## CITY OF NEW BEDFORD

# **Driveway Review Form**

Address: 16. Norman st

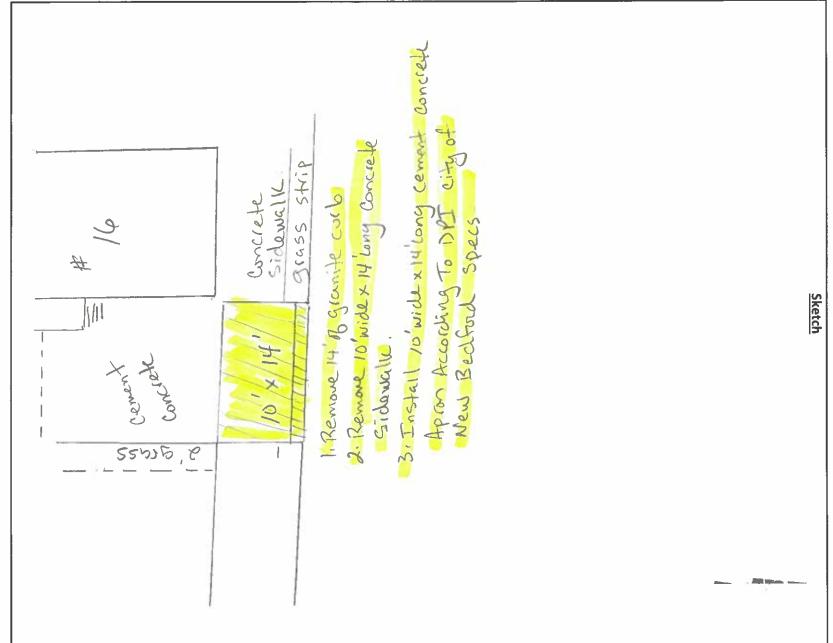
specs .4 Need to have traffic remove no parking from here to corn sign Install 10 ft wide x 14 ft long cement concrete apron according to city of New Bedford DPI 1.Remove 14 ft of granite curb .2 Remove 10 ft wide x 14 long concrete sidewalk .3
